**RE: Bernalillo County THV  
Grading and Drainage Plan  
Engineer's Stamp Date: 12/30/19  
Hydrology File: K19D138**

**RE: Bernalillo County THV  
Grading and Drainage Plan  
Engineer's Stamp Date: 08/05/19  
Hydrology File: K19D138**

Based upon the information provided in your submittal received 10/23/2019, the Grading & Drainage Plan **is not** approved for Building Permit. The following comments need to be addressed for approval of the above referenced project:

BAKER, MARK - TINY HOME VILLAGE - GRADING & DRAINAGE PLAN

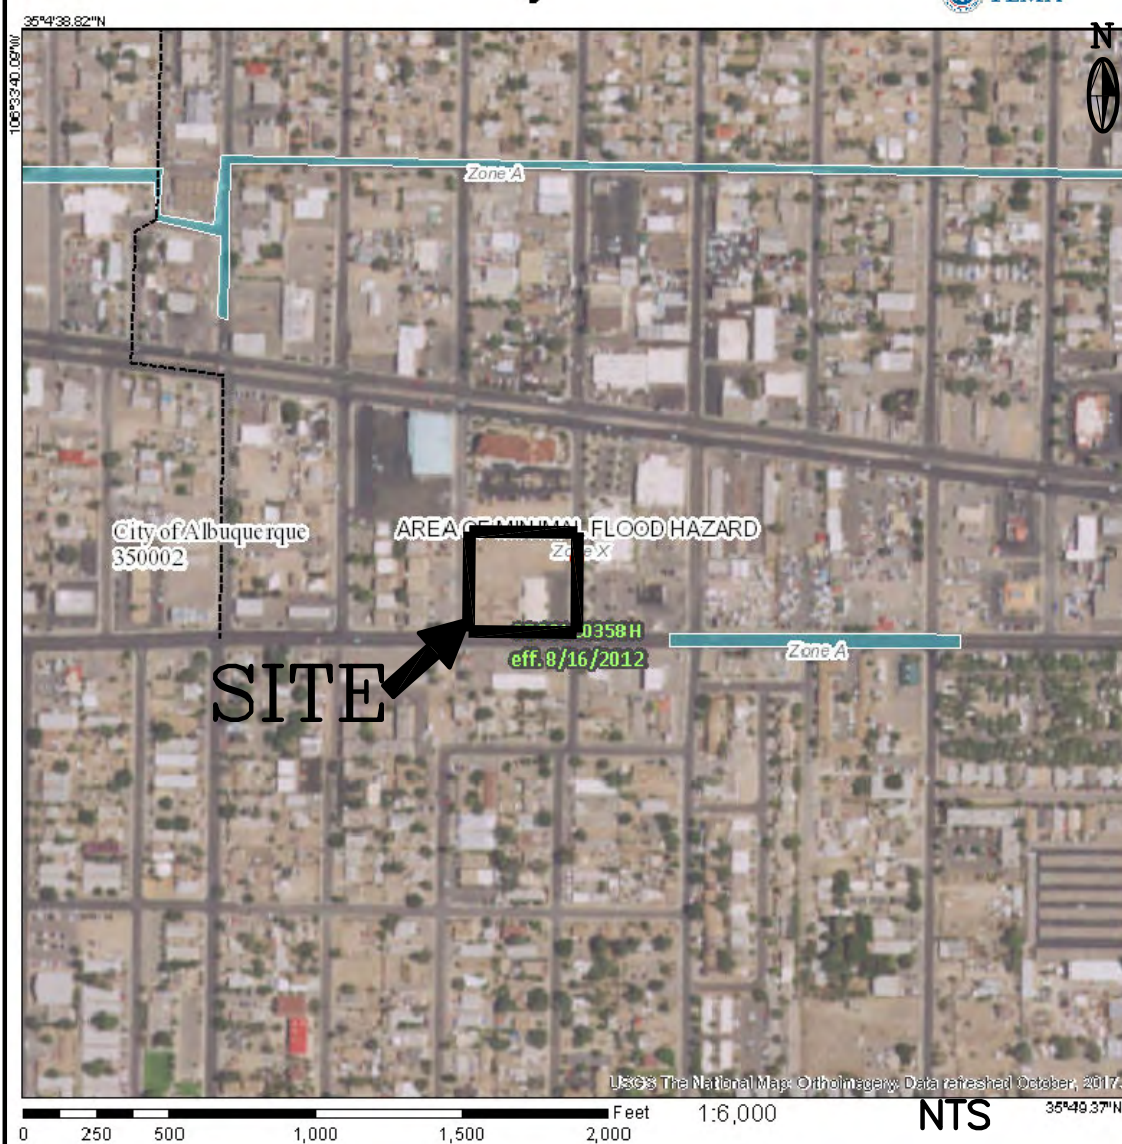
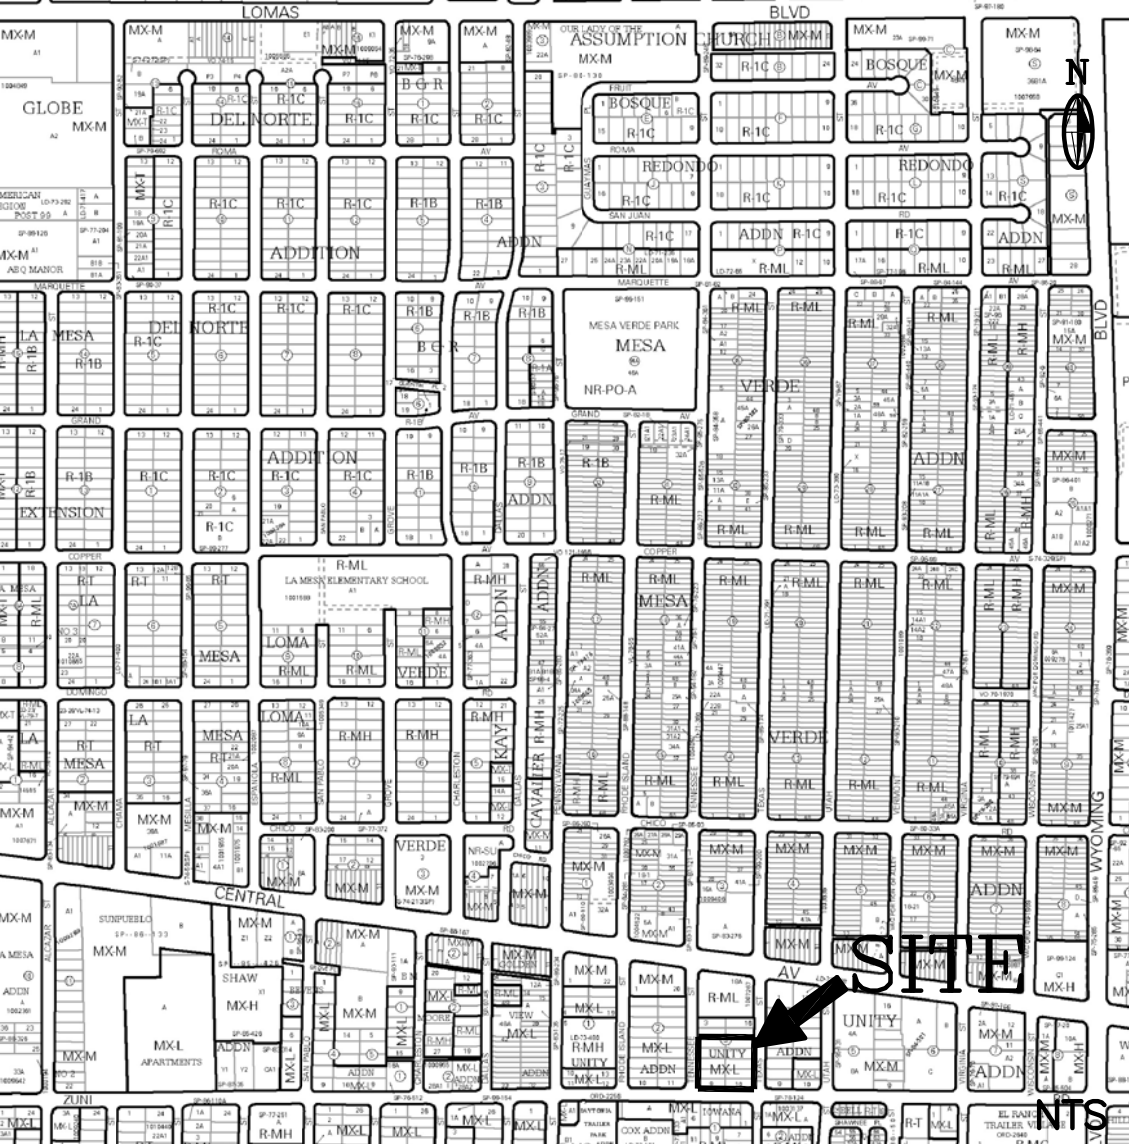
1. First off, this site is currently being replatted into two tracts. Tract 5-A (the subject THV) and Tract 12-A (the existing Albuquerque Indian Center). See attached Preliminary Plat. Please show these two new tracts. **OK**

2. Please shade back all existing items. Also please just show the existing building outline on Tract 12-A. **OK**
3. As you can see on the Preliminary Plat, there is a Right-of-Way dedicated to the City of Albuquerque. A portion of stormwater quality pond is within this new Right-of-Way. Please correct. **OK**

4. Since the site is being replatted into two tracts, please correct the Existing Conditions. Please note that Tract 12-A (the existing Albuquerque Indian Center) drains to the east and onto Texas. Tract 5-A (the subject THV) does drain to the west towards Tennessee. **OK**

5. Please correct the address for this project. 105 Texas is for the existing Albuquerque Indian Center.  
**New address for THV has been added and AIC existing address has been shown**

6. Please update the drainage calculations. These should be just for Tract 5-A. **OK**
7. Please clean up all the overlapping text. It is very hard to read.

8. Talking to the Transportation Section, all three existing driveways on Tennessee need to be closed off and removed. Please add a note stating that the driveways will be removed and a proposed sidewalk and curb & gutter will be added to match existing grades. **OK**

9. Please add two spillways for the stormwater quality ponds via sidewalk culverts at the elevation of the required stormwater quality volume. One for the northwest pond and one for the southwest pond. These should be right where two existing driveways are being removed. Also please label the inverts both at the pond and at the gutter. **OK**

10. Please add a note install sidewalk culverts per CoA drawing 2236. **OK**
11. Please add the attached SO-19 notes for the two sidewalk culverts. **OK**

12. Please provide the weir calculations, per DPM Chapter 22.3.A.1, for the sidewalk culverts. A coefficient of 2.7 is typically used for the weir equation  $Q = CLH^{2/3}$ . **OK**

13. Please label both stormwater quality ponds with the provided volume and elevation. Please note that the table for the stormwater quality calculations should show a list of the three ponds with the provided volumes with a total provided volume.

**there is one pond which merges together - labels and volume shown**
14. For Section A-A. Please add the location of the property line and label each side of this line with an arrow and either Tennessee R.O.W. or Tract 5-A. **OK**

**OK - did the best we could as to not impact the necessary information.**

SPILLWAY VIA 1' WIDE  
SIDEWALK CULVERT  
INV. IN=72.00  
INV. OUT=71.80  
(MATCH EXISTING  
GRADE)

INSTALL SIDEWALK  
CULVERT PER COA  
DWG. 2236

SPILLWAY VIA 1' WIDE  
SIDEWALK CULVERT  
INV. IN=73.04  
INV. OUT=72.84  
(MATCH EXISTING  
GRADE)
